Job Title
CNG HINKLEY WATLING STREET

Drawing Title
DMRB REVIEW OF SWEEP PATH ANALYSIS OF SITE ACCESS OFF WATLING STREET - 16.5m ARTIC

**CNG FUELLING FACILITY, WATLING
STREET, HINCKLEY, LE10 3ED**

TRANSPORT STATEMENT ADDENDUM

Scale 1:500 @A1	Date DEC' 25	Designed LG
Drawn LG	Checked BO	Approved MB
Job No 22-240	Drawing No 22-240-123	Rev B

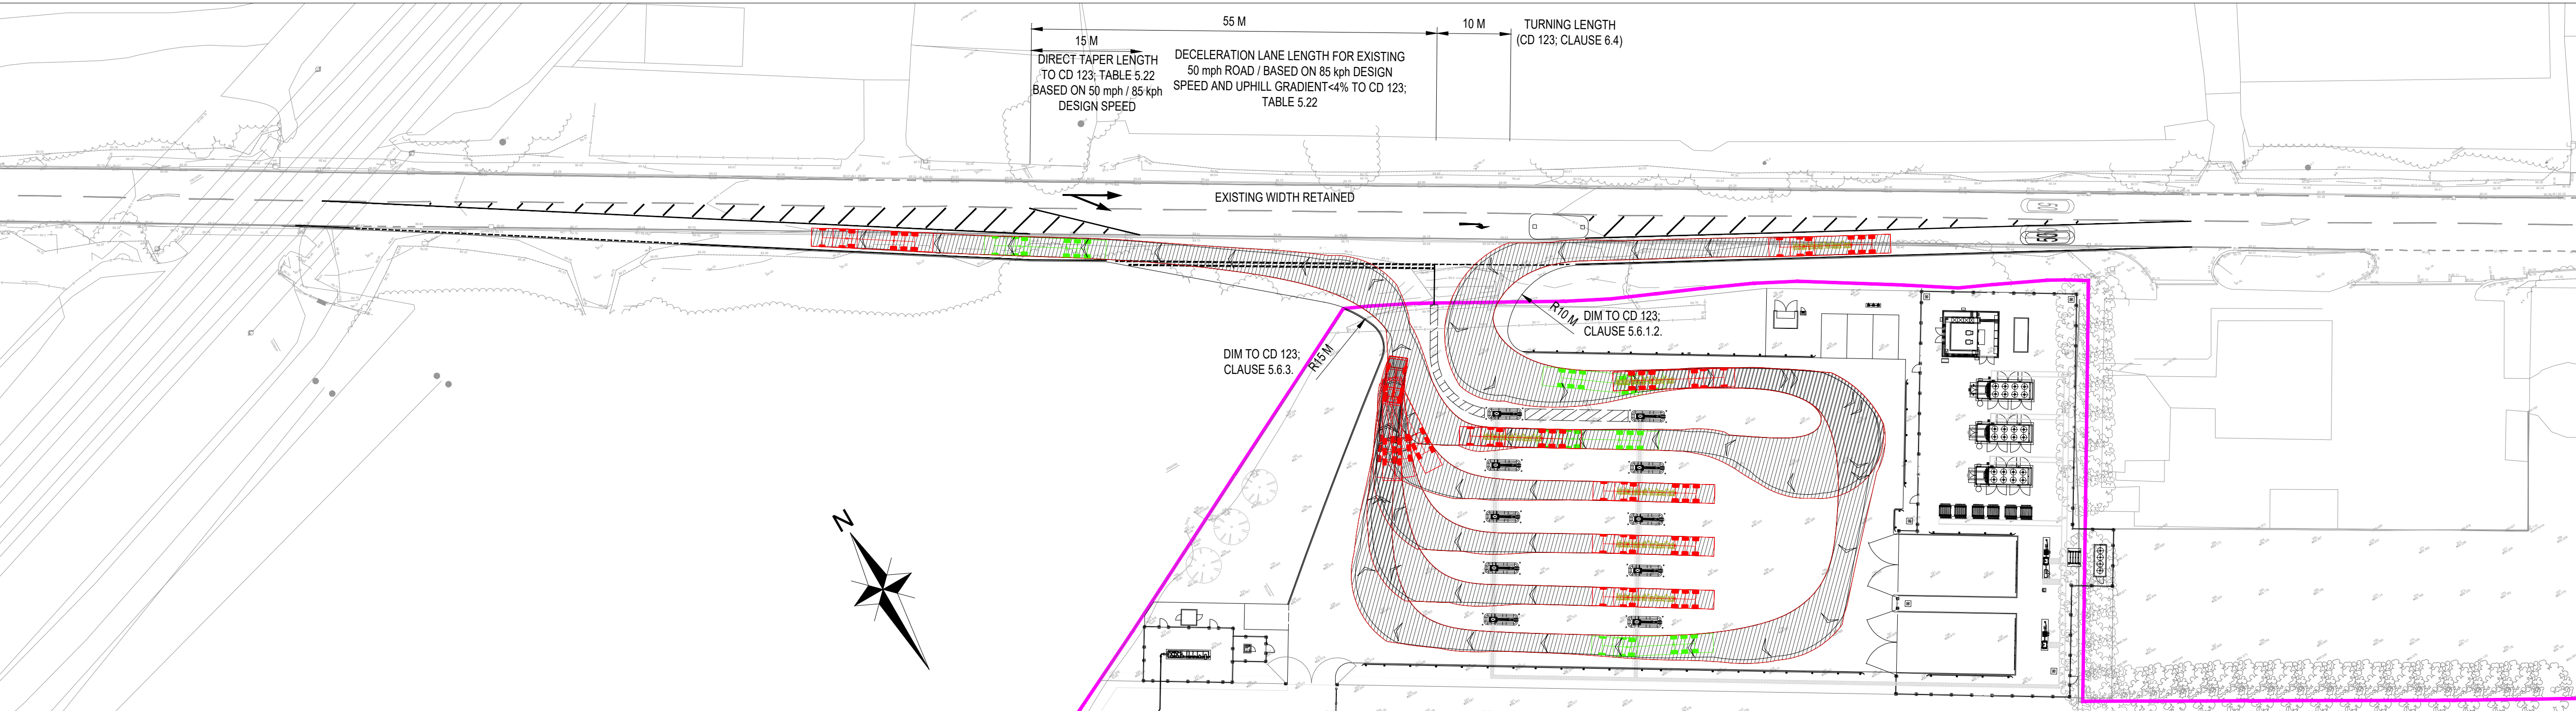
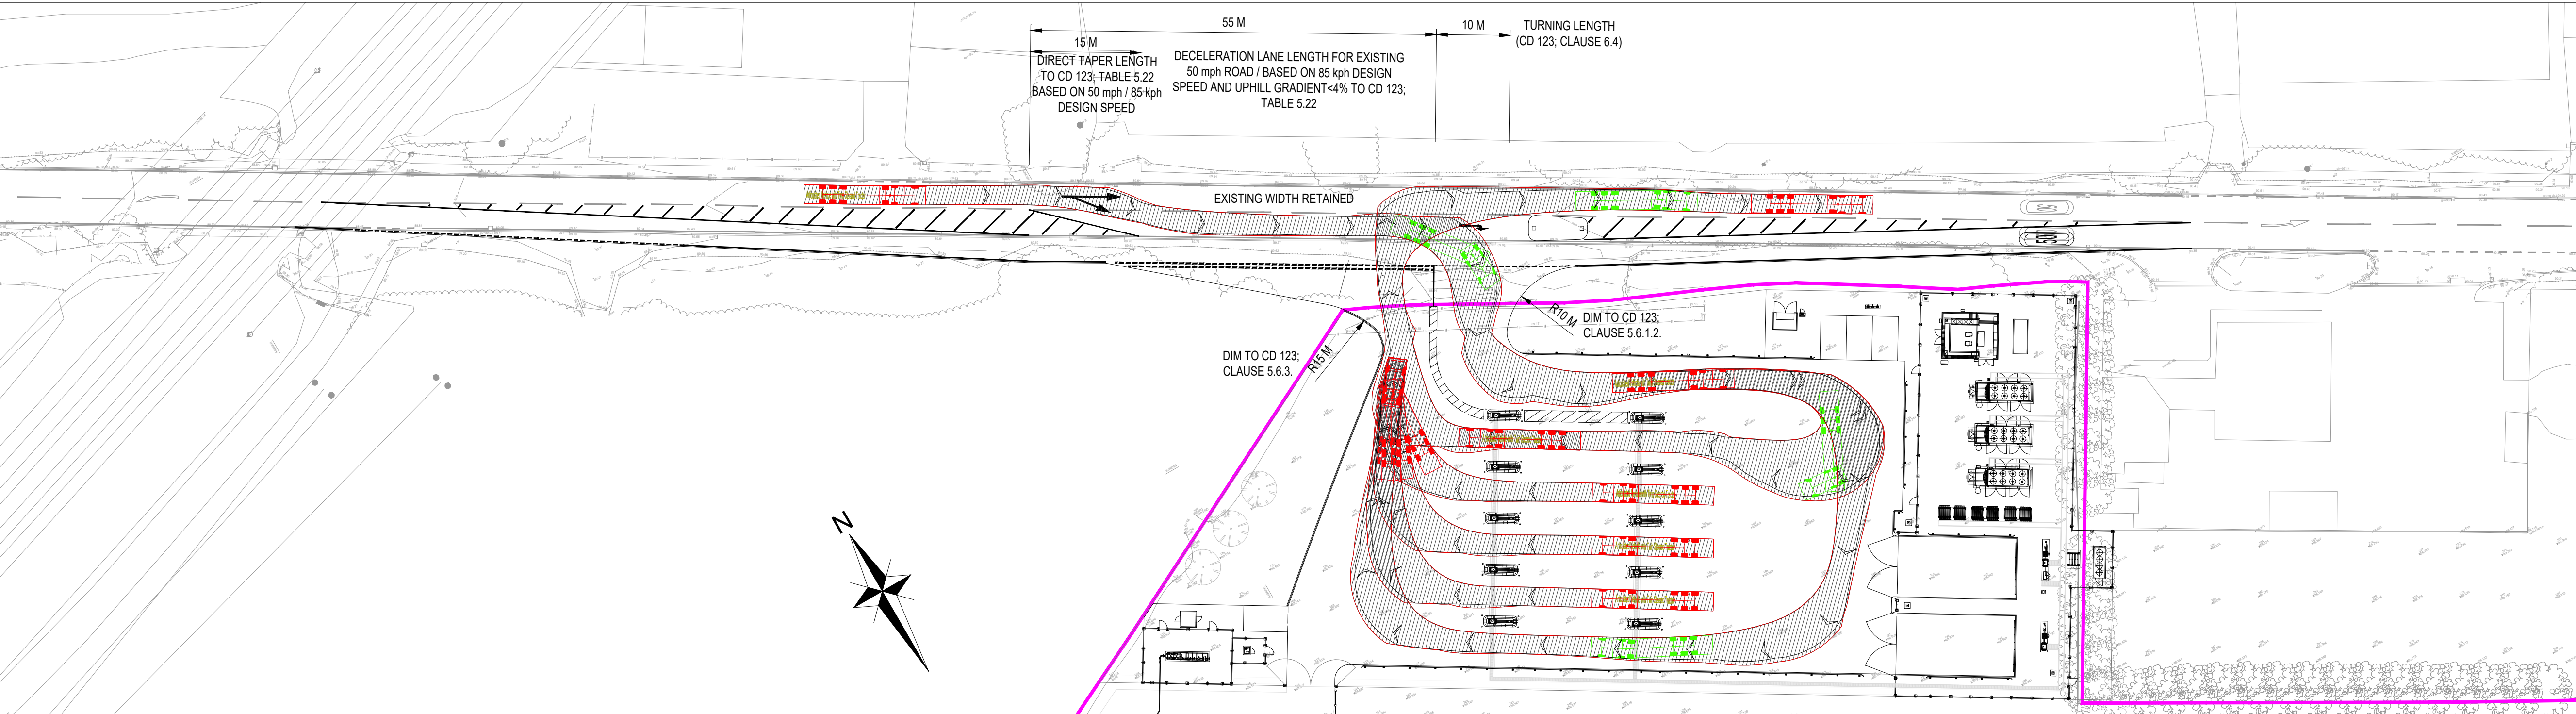
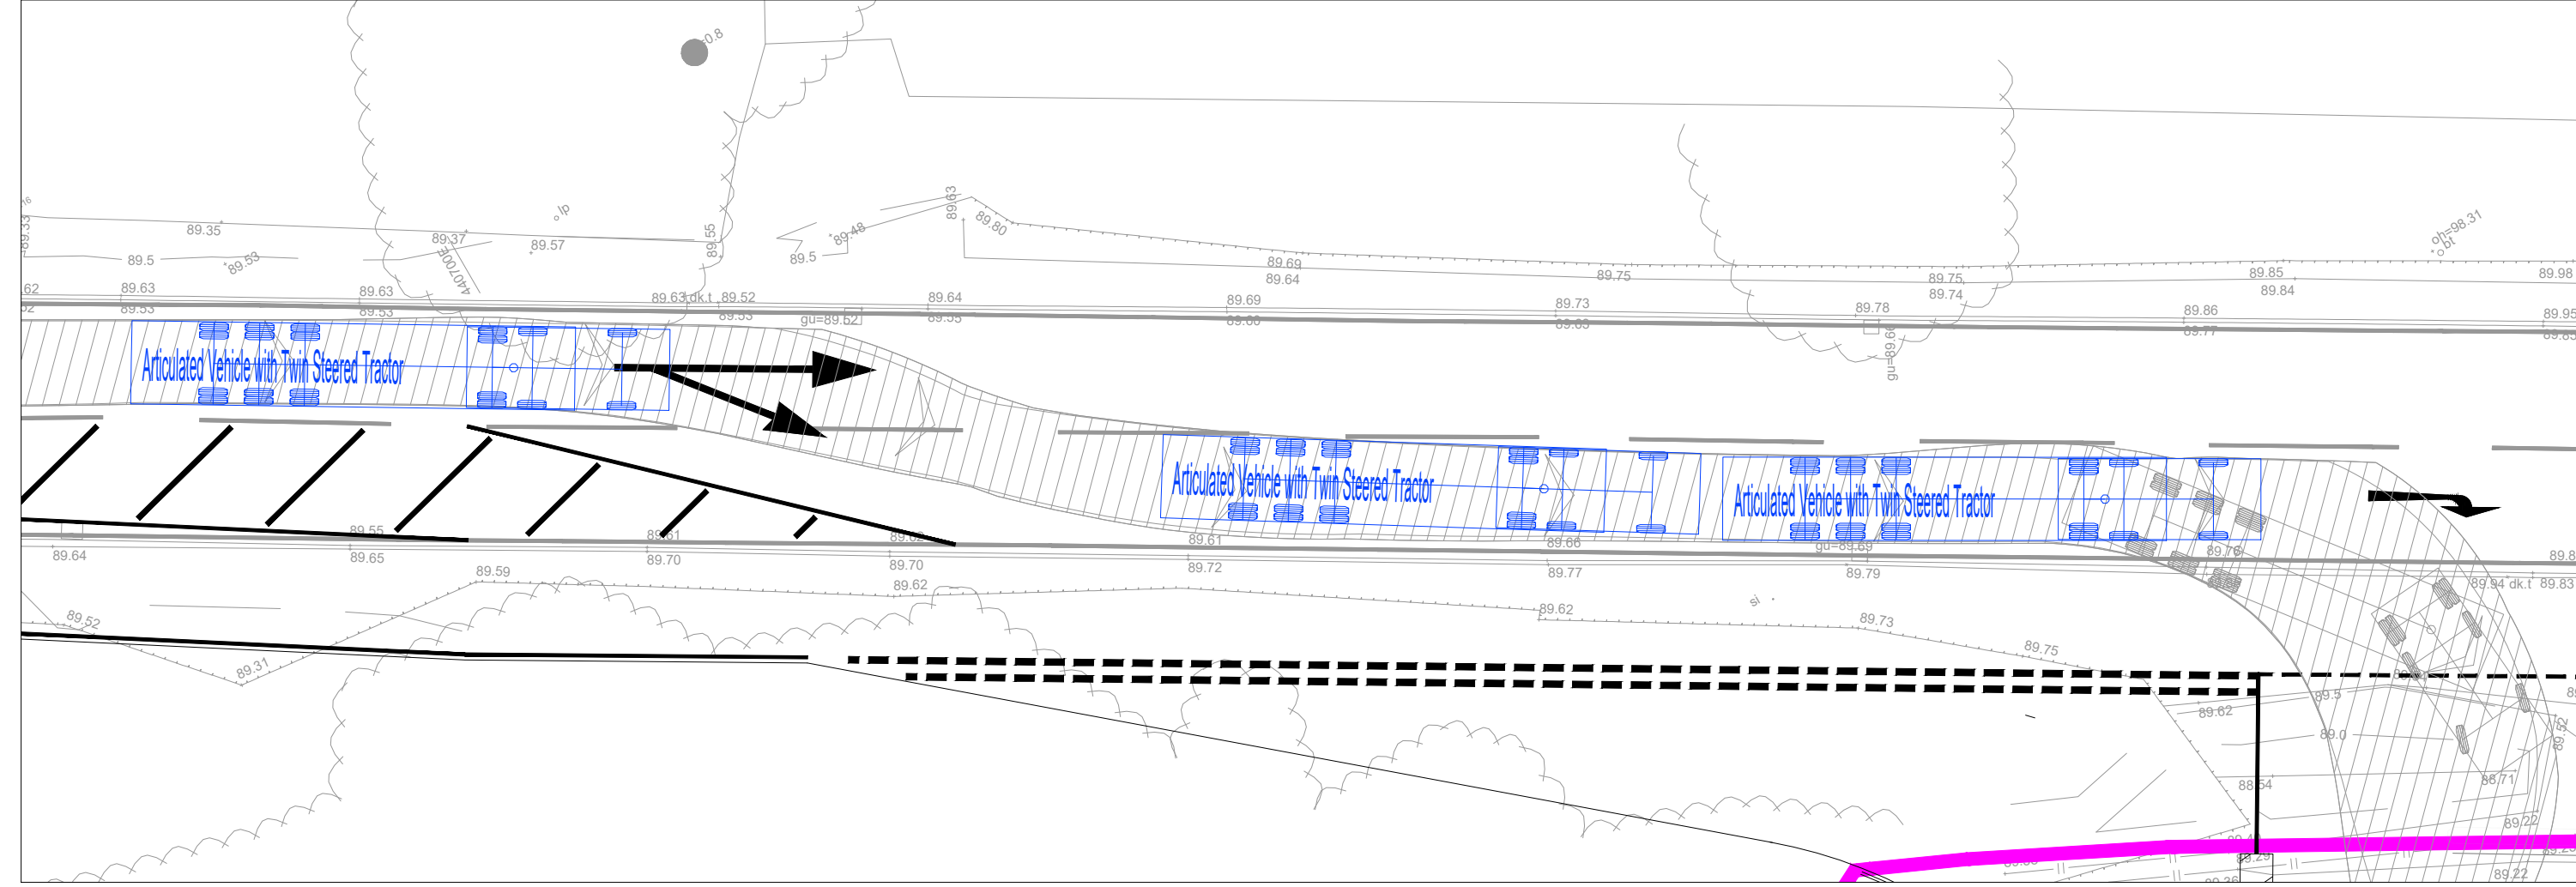
Rev	Amendments	Dm	Chk	App	Date
B	TRAFFIC ISLAND ADDED EAST OF SITE ENTRANCE FOLLOWING RSA1 COMMENTS	LG	BO	MB	29.04.26
A	EXTRACT ADDED SHOWING 2 VEHICLES WAITING IN DECELERATION LANE	LG	BO	MB	27.01.26
